LINCOLN CITY/LANCASTER COUNTY PLANNING STAFF REPORT

for June 7, 2006 PLANNING COMMISSION MEETING

PROJECT #: Preliminary Plat #06004

PROPOSAL: Preliminary plat consisting of approximately 428.61 acres and 1,120 lots to be developed with approximately 1,850 dwelling units to include detached single-family, attached single-family, townhouses, and multi-family units.

WILDERNESS HILLS 1ST ADDITION
Site Plan
Lincoln, Nebraska

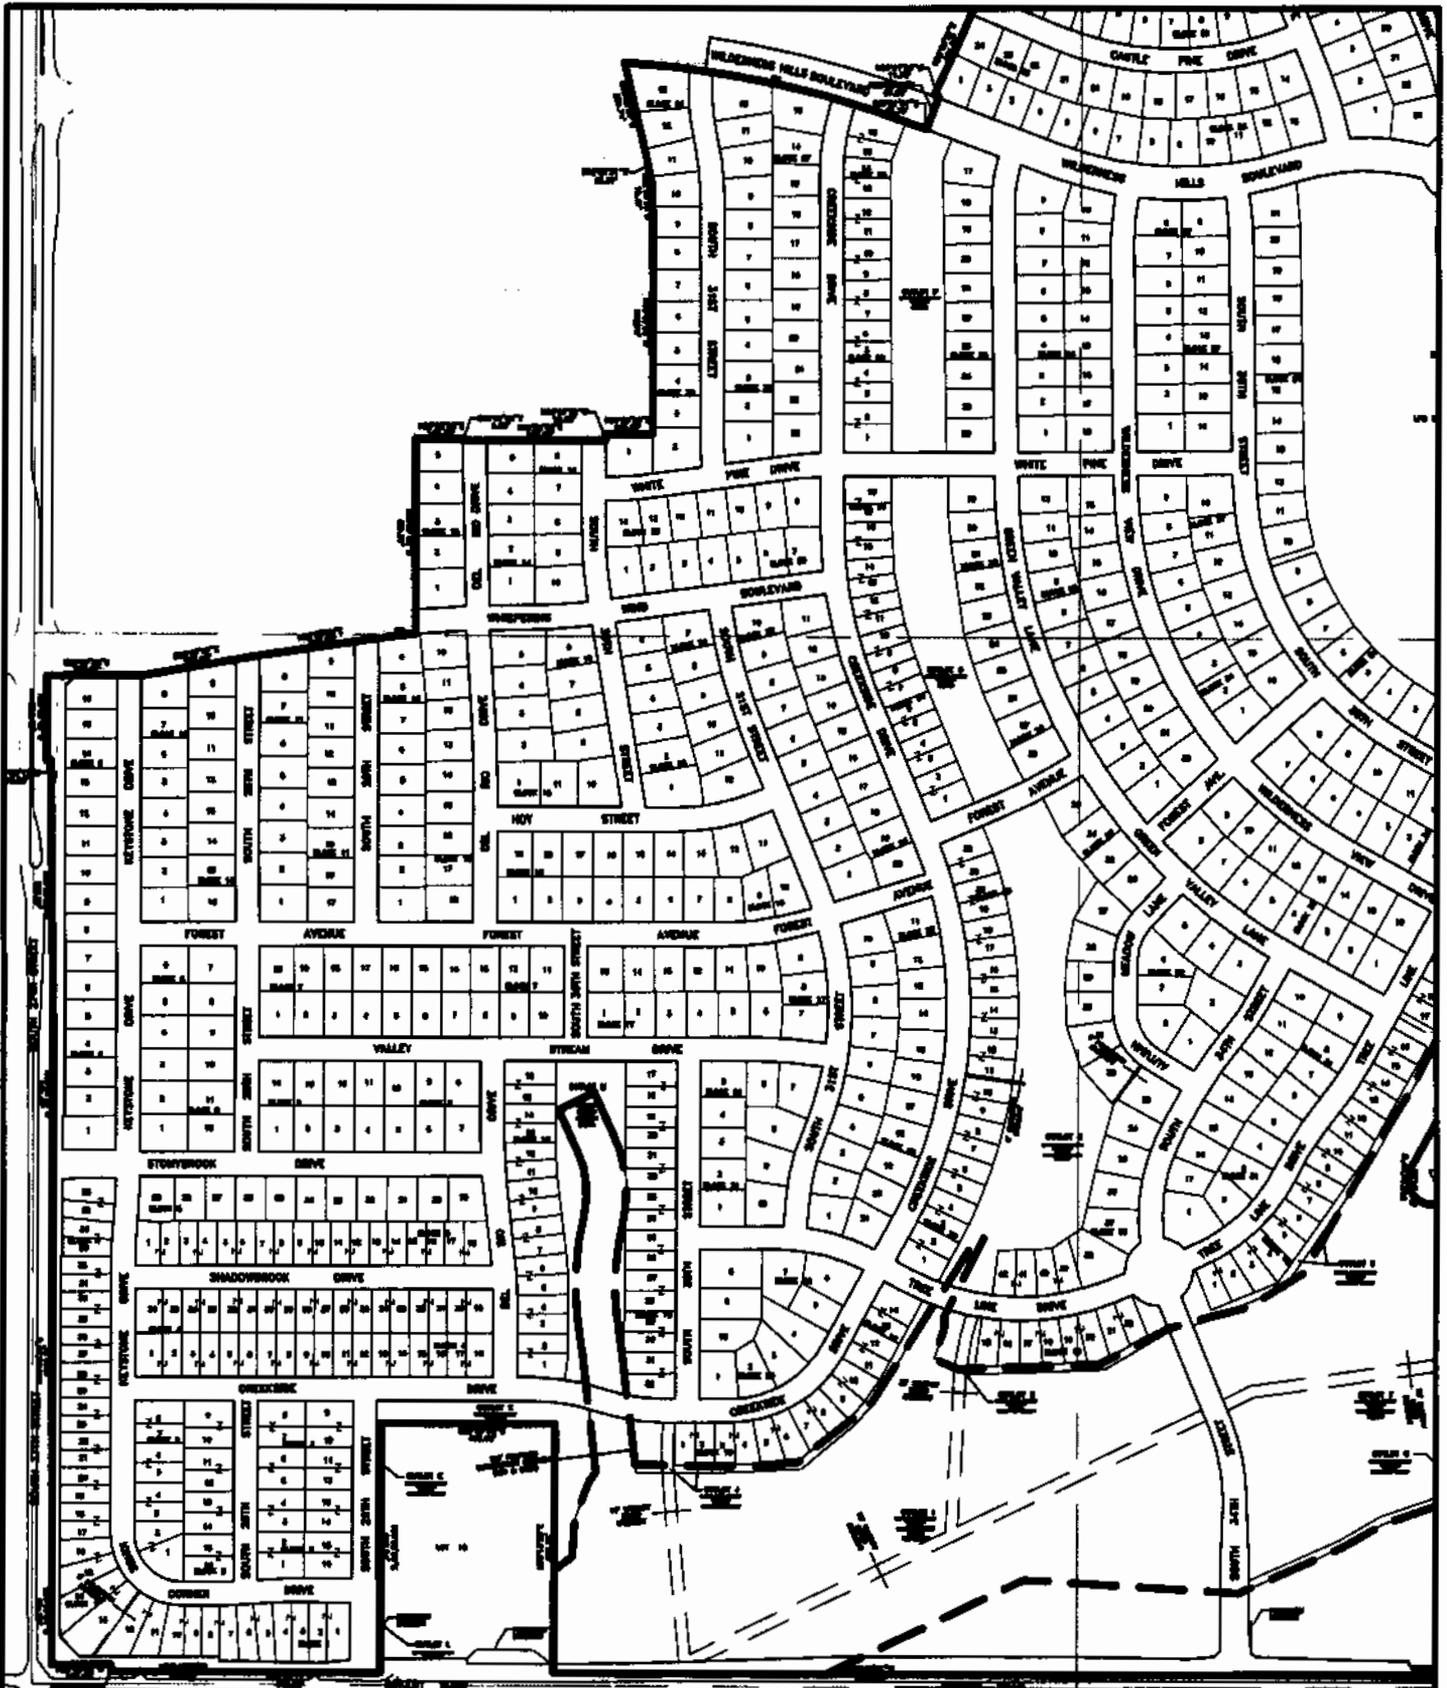
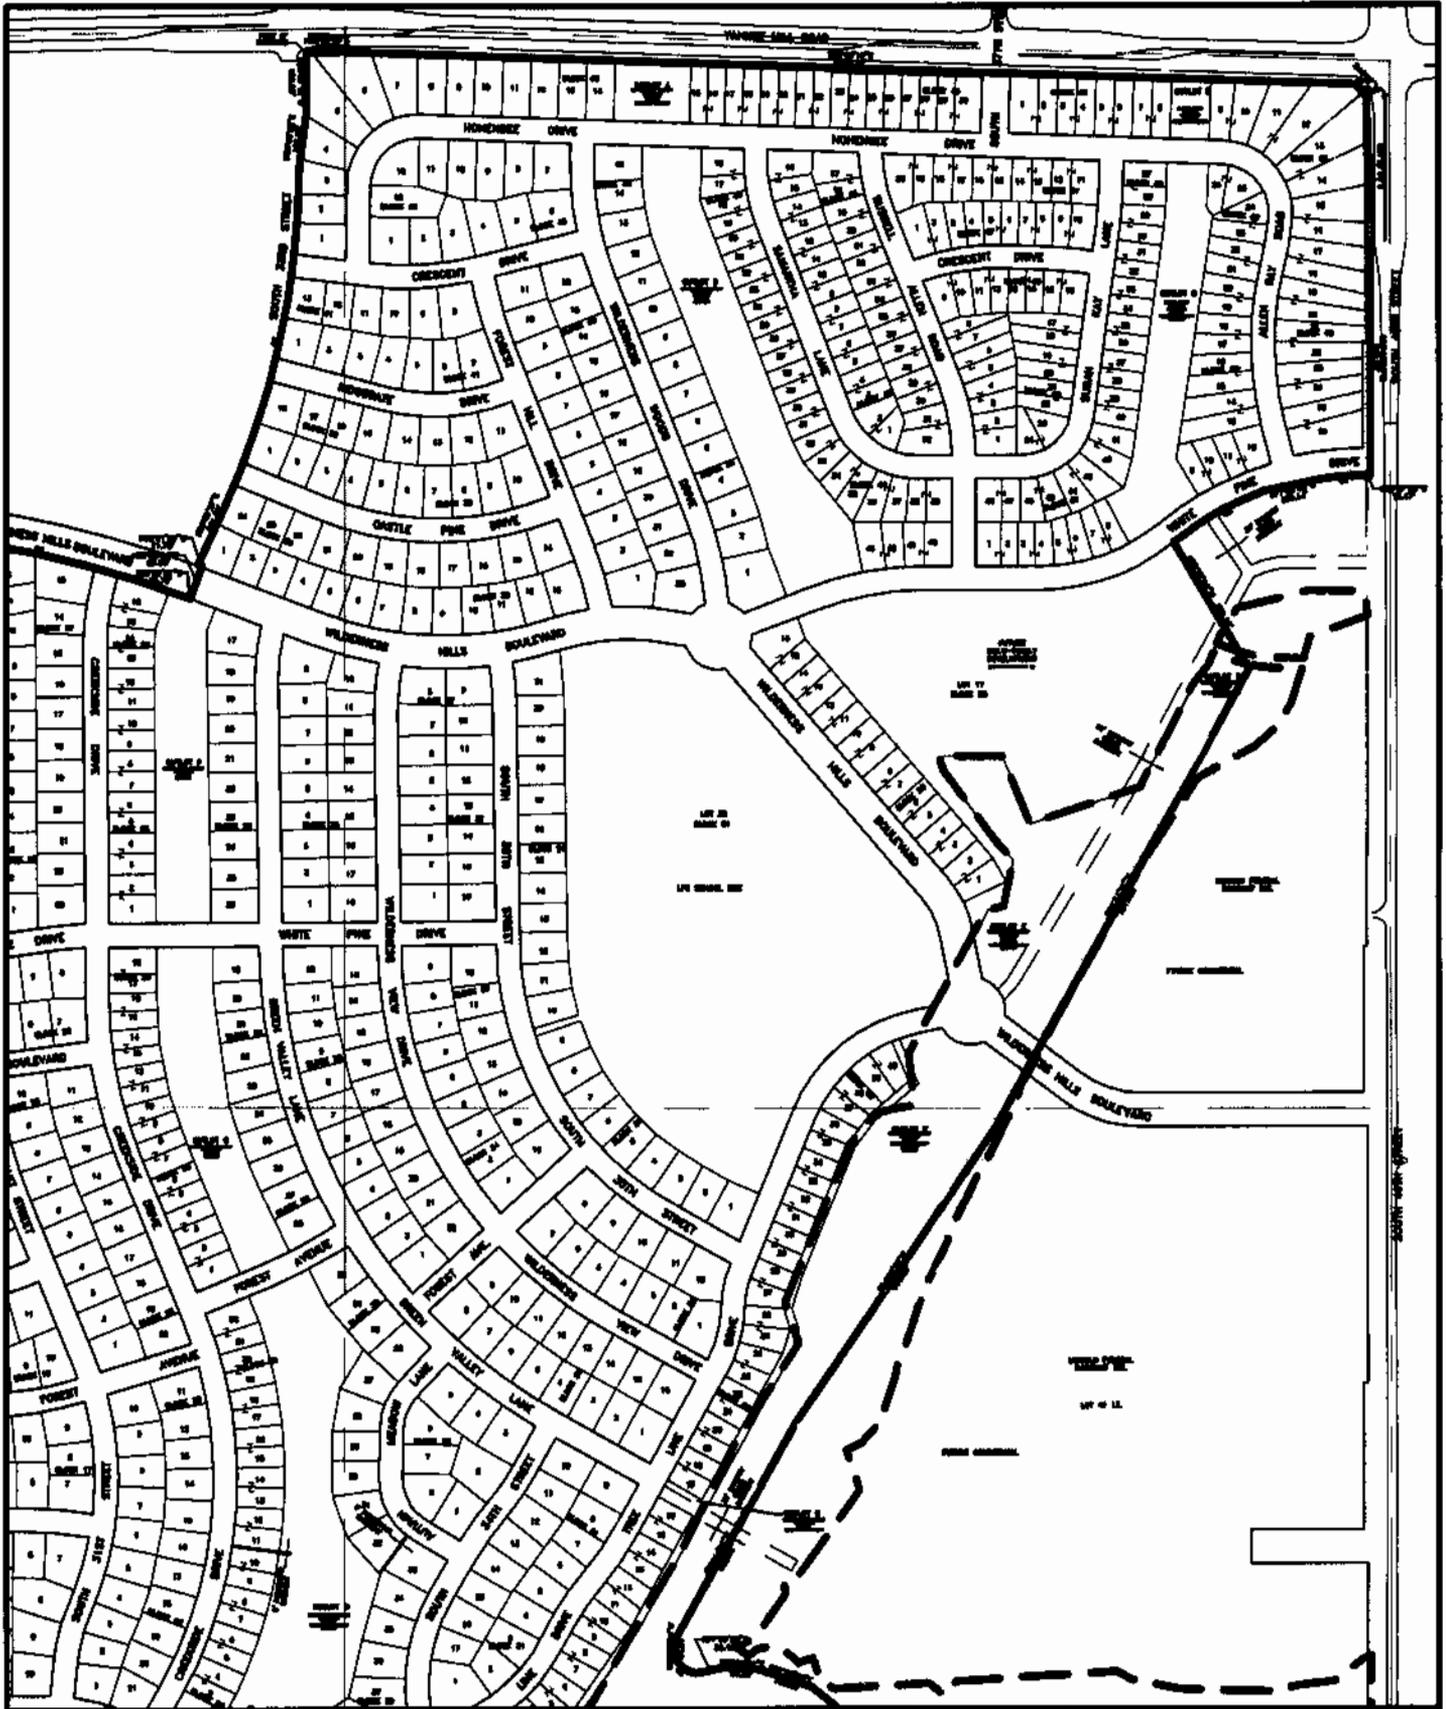
8. The mid-block access between Lots 8 & 9 Block 50 should be eliminated to discourage youth from accessing the school site via this area and making a potentially dangerous mid-block street crossing.

9. Provide more direct pedestrian and vehicular access to the LPS school site from the portion of this development that lies west of Outlots N, O, and P by extending Forest Avenue from its current terminus at Green Valley Lane through to S. 35th Street and White Pine Drive from its terminus at Wilderness View Drive through to S. 35th Street. Provide pedestrian access easements from the intersection of White Pine Drive and Forest Avenue with S. 35th Street to the school site. By making these changes, the proposed alignment of Forest Avenue as it exists now may be eliminated as well as that portion of White Pine Drive between S. 30th Street and Creekside Drive.

10. Modify the alignment of Wilderness Hills Boulevard at its intersection with White Pine Drive and Wilderness Woods Drive such that the boulevard will approach the roundabout at a southeastward angled arc to provide the driver the impression that Wilderness Hills Boulevard continues on southeastward from this intersection and to discourage traffic from continuing eastward onto White Pine Drive.

11. Some concerns have been raised over proposed street names. Due to addressing concerns, S. 30th Street between Forest Avenue and Valley Stream Drive must be renamed a non-numbered street and Creekside Drive must be renamed west of its intersection with Tree Line Drive given one new name, and north of its intersection with Tree Line Drive given a second new name, preferably S. 32nd Street. Additionally, White Pine Drive is used to name two different sections of roads that do not align with one another. At least one of these sections must be renamed.

12. Because S. 37th Street will provide full access to Yankee Hill Road, staff suggests that the site plan be modified so that this street can be extended beyond its current terminus at Hohensee Drive southward to White Pine Drive. In general, collector roads with full access points to adjacent arterials should penetrate into a development a minimum of 3 to 4 blocks.

18. Watershed Management comments:
 - 18.1 Potential flooding may occur beyond the boundaries of the conservation easement at the following locations: Block 50, Lots 2-5 upstream of S. 34th Street, Block 19, Lots 1-10 and 15-19 downstream of S. 34th Street, and adjacent to the future commercial area east of the stream and conservation easement. Revise the grading and drainage plans to show no flooding beyond the proposed boundaries of the conservation easement.

- 1.1 Revise the site plan and the plat to show the street layout to the satisfaction of the Planning Department as discussed in Items 9 and 10 of this report.

- 1.2 Revise the site plan and the plat to eliminate the pedestrian access between Lots 8 and 9, Block 50.
 - 1.3 Revise the site plan and plat by changing proposed names of the streets as described in Item 11 of this report.
